Westinghouse
Electric Corporation

NSD-NRC-97-5194
DCP/NRC0923
Docket No.: STN-52-003

June 18, 1997

SUBJECT: CONTAINMENT SCREENS AND STRAINERS

Figure 6.3-6 IRWST Screen Plan Location

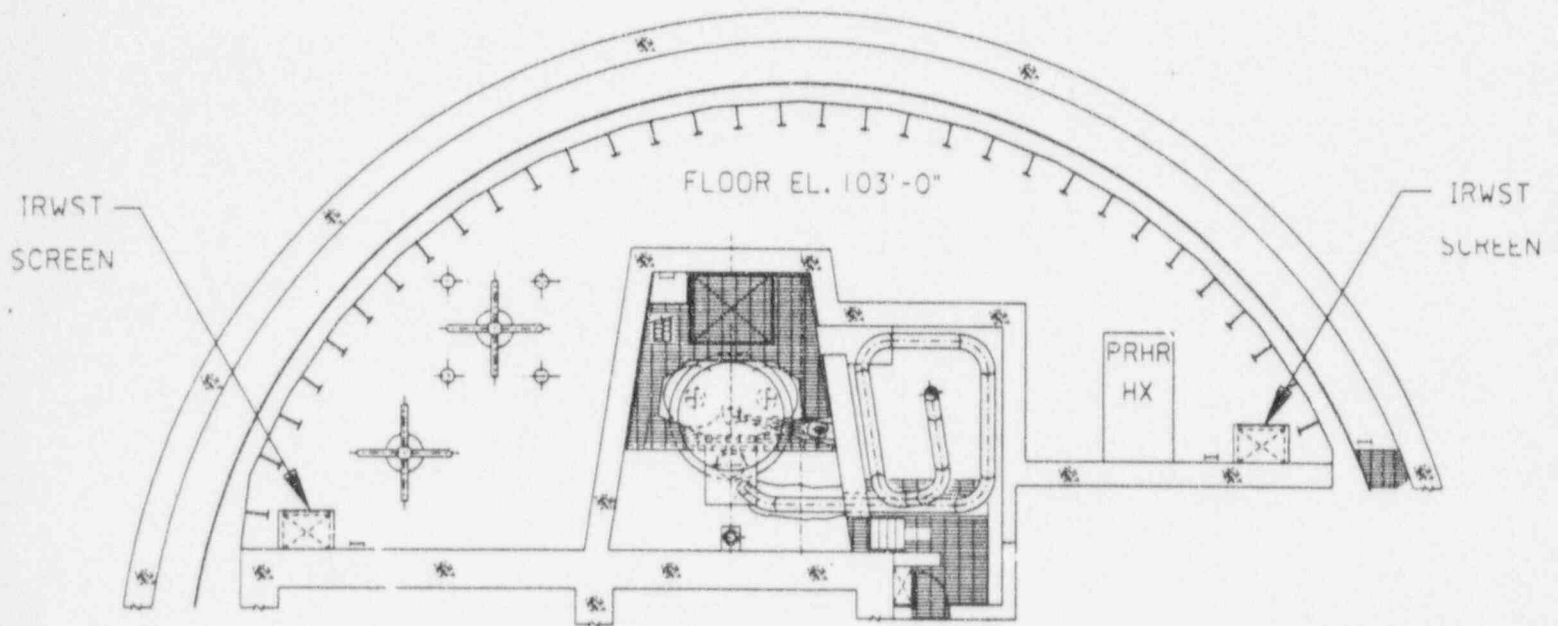
The staff is concerned that the strainers in the IRWST and containment sumps could be clogged by debris. Important factors are the use of non-safety related coatings in the AP600, and possible sensitivity in this design to screen clogging because of dependence on gravity-driven flows. (DSER Open Item 6.2.1.8-1).

The containment recirculation screens and IRWST strainers are designed in conformance with RG 1.82 and to address the technical concerns raised in Generic Safety Issue A-43, "Containment Emergency Sump Performance." The staff provided further clarification of these concerns in Bulletins 96-03 and 95-02. The staff disagrees with Westinghouse's assessment that these bulletins only apply to boiling water reactor designs and are not applicable to the AP600 strainer design. Westinghouse needs to document in the SSAR what actions will be taken to address the conditions described in these bulletins on the IRWST strainer design. Design commitments resulting from the review of RG 1.82, GSI-43, and the bulletins should be incorporated into the ITAAC.

The IRWST screens are located inside the IRWST at the bottom of the tank. Figure 6.3-6 shows a plan view and Figure 6.3-72 shows a section view of these screens. Two separate screens are provided in the IRWST, one at either end of the tank. The IRWST is closed off from the containment; its vents and overflows are normally closed by louvers. The potential for introducing debris inadvertently during plant operations is limited. A COL cleanliness program (refer to 6.3.8.1) controls foreign debris from being introduced into the tank during maintenance and inspection operations. The Technical Specifications require visual inspections of the screens during every refueling outage.

The design of the IRWST screens reduces the chance of debris reaching the screens. The screens are orientated vertically such that debris that settles out of the water does not fall on the screens. A debris curb located at the base of the IRWST screens prevents high density debris from being swept along the floor by water flow to the IRWST screens. The IRWST screens are made up of a trash rack and a fine screen. The trash rack prevents larger debris from reaching the finer screen. The fine screen prevents debris larger than 0.25" from being injected into the reactor coolant system and blocking fuel cooling passages.
